EDG RESPONSE

The proposed development is a mid-rise multifamily residential structure stepping down from 12 to 10 stories, comprising 100 units of housing with 71 parking stalls, mostly below grade. Tenant amenities will be provided on the upper and lower roofs. No commercial spaces will be provided.

The Design Review Board reviewed three concepts at the previous Early Design Guidance meeting. The Board's discussion and deliberation centered around both the "Interlock" and the "Folded Veil" concepts. Certain positive attributes of both of these concepts were identified and have been integrated into and developed in the preferred concept for the Board's further consideration and recommendation.

1 VOLUMETRICS

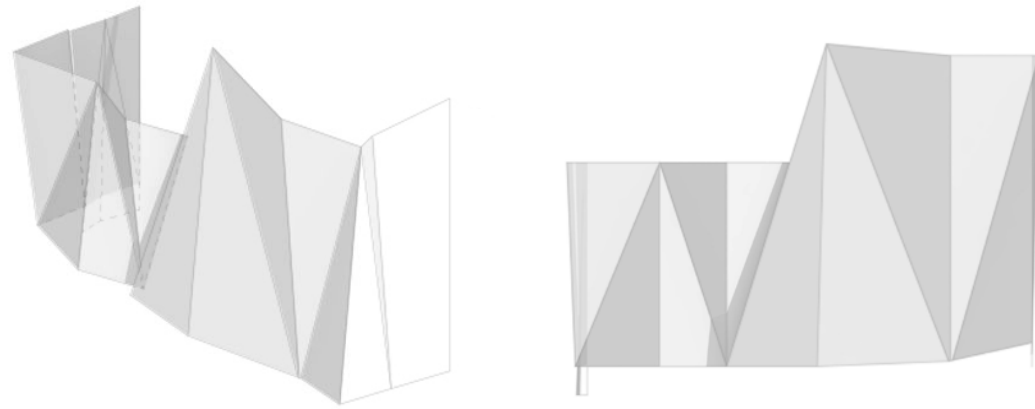
“Board members were not so concerned with the height of the “step” in massing of the building which was dictated by the interaction of the site topography and Land Use Code.” *

“BE ELEGANT”

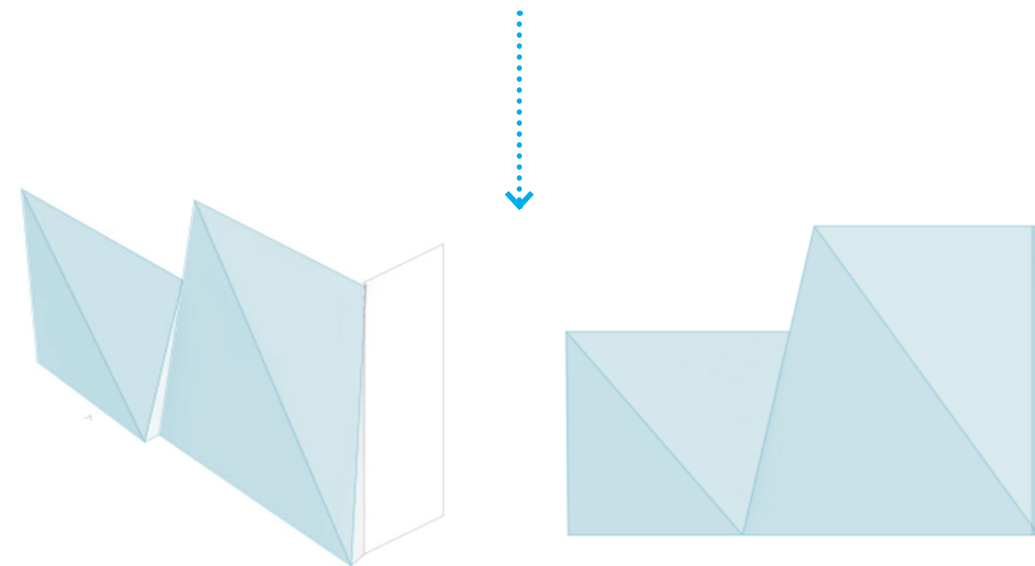
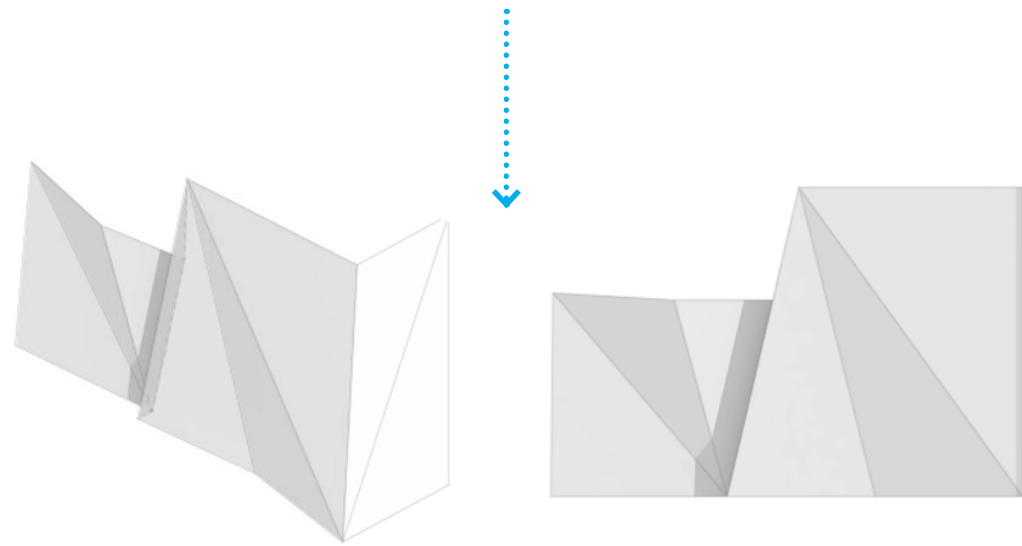
“The consensus direction was to “be elegant”, but “be quieted” paying attention to the ‘veil’s materiality, ability to mute the balconies potential obtrusiveness, and integration into all the facades of the building.” *

“Folded Veil” reviewed at EDG: 8 folds, perforated metal

“Folded Veil” proposed: 2 folds, glass with metallic inner layer

“UNIFY AND INTEGRATE”

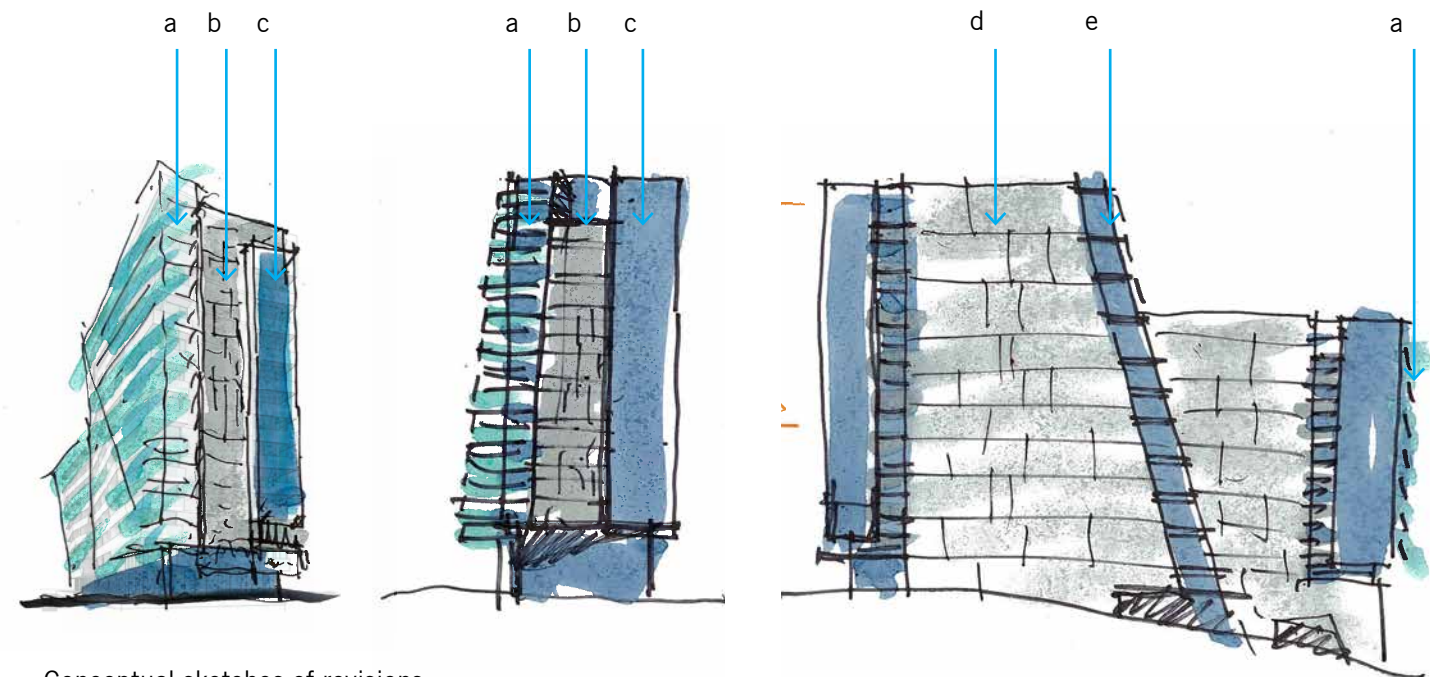
The overarching concept of the "Folded Veil" was supported by the Board, with additional guidance to "quiet" the project and to strive for refinements that achieve elegance and conceptual unity and allow the building to be read as a work of architecture, acknowledging that while the building may have a sculptural quality it should be well considered and crafted.

The preferred concept of the “Folded Veil” has been substantially refined to unify the concept design and to integrate the veil into an overall composition of the building.

- a) veil turns corners
- b) taut infill at privacy zone
- c) full height windows at occupied zones
- d) expression of structure
- e) “slit” at height transition and stair
